**SUBJECT: PEACH BOTTOM ATOMIC POWER STATION, UNITS 2 AND 3 - ISSUANCE
OF AMENDMENTS RE: EXTENDED POWER UPRATE (TAC NOS. ME9631
AND ME9632)**

The U.S. Nuclear Regulatory Commission (NRC) has issued the enclosed Amendment Nos. 293 and 296 to Renewed Facility Operating License Nos. DPR-44 and DPR-56 for Peach Bottom Atomic Power Station (PBAPS), Units 2 and 3. These amendments consist of changes to the Technical Specifications (TSs) and Facility Operating Licenses (FOLs) in response to your application dated September 28, 2012,¹ as supplemented by additional letters².

The amendments authorize an increase in the maximum licensed thermal power level for PBAPS, Units 2 and 3, from 3514 megawatts thermal (MWt) to 3951 MWt, which is an increase of approximately 12.4 percent. The NRC considers the requested increase in power level to be an extended power uprate (EPU).

Figure 3.1.7-1 (page 1 of 1)
Sodium Pentaborate Solution Temperature Versus Concentration Requirements

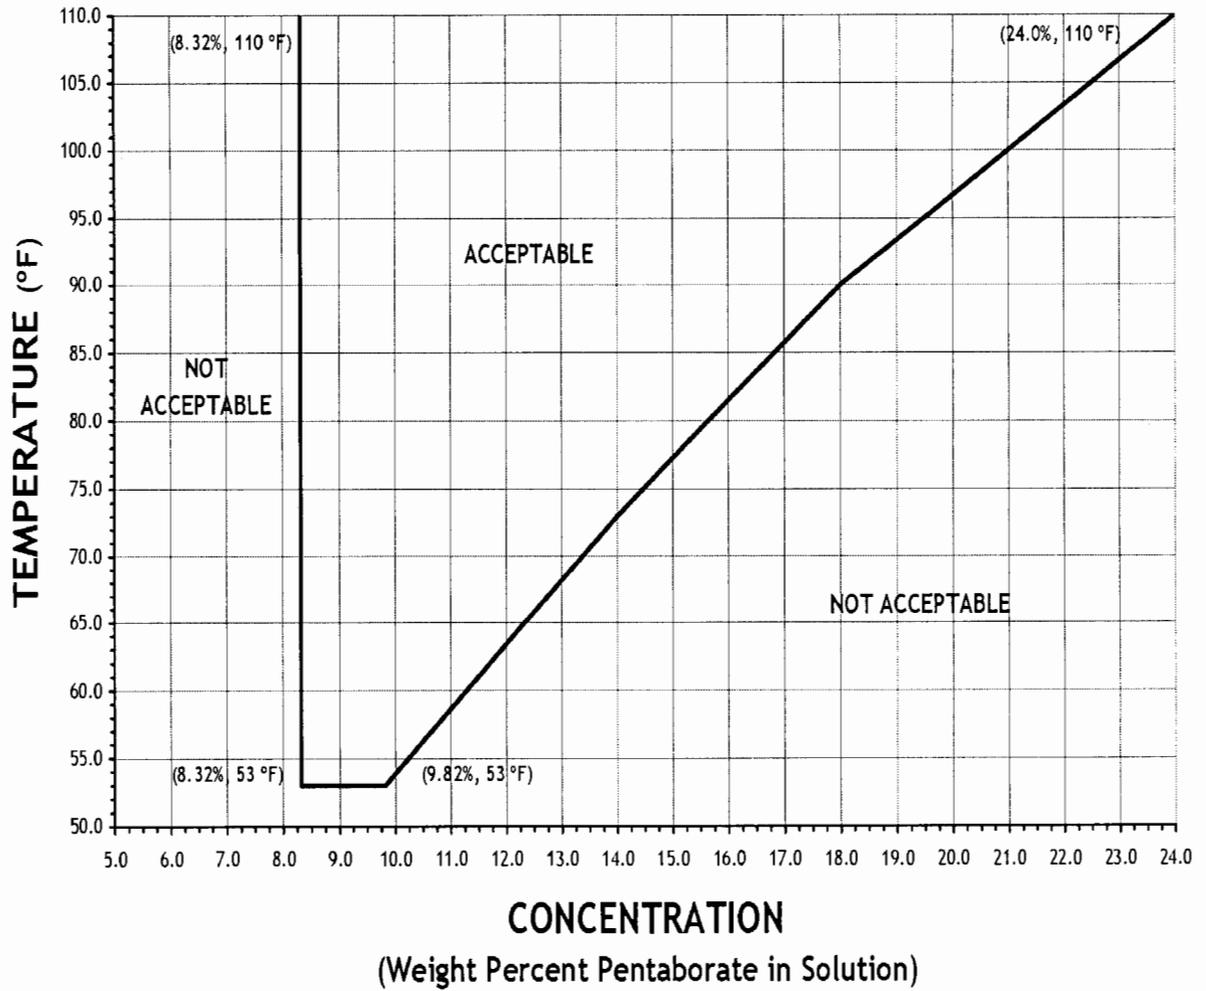
Figure 3.1.7-1 provides a graph of sodium pentaborate solution temperature versus concentration. As discussed in the TS Bases, this figure ensures that a 10 °F margin will be maintained above the saturation temperature so that boron does not precipitate out of solution in the storage tank or in the pump suction piping due to low boron solution temperature (below the saturation temperature for the given concentration). The proposed amendment would revise the figure to show the minimum concentration of $\geq 8.32\%$ weight that would be incorporated into SR 3.1.7.5 and to more clearly depict the "not acceptable" area for maintaining sodium pentaborate concentrations.

As discussed in Section 3.1.4 of Attachment 1 to the EPU LAR, the equivalency equation in Table 3.1.7.1 would no longer reflect the PBAPS design basis following the EPU. Therefore, the equivalency equation is being replaced (i.e., deletion of Table 3.1.7-1) with specific limits, for EPU conditions, in SR 3.1.7.5, SR 3.1.7.8, SR 3.1.7.10, and Figure 3.1.7-1. The NRC staff finds that the proposed changes will provide clearer direction to the plant operations staff in maintaining the associated SLC system parameters (i.e., versus the current equivalency table

method). In addition, the NRC staff finds that the proposed changes will continue to ensure proper balance of boron concentration, SLC pump flow, and B-10 enrichment consistent with the requirements in 10 CFR 50.62(c)(4). Based on these findings, the NRC staff concludes that the proposed changes to SR 3.1.7.5, SR 3.1.7.8, SR 3.1.7.10, and Figure 3.1.7-1, and the proposed deletion of Table 3.1.7.1 are acceptable.
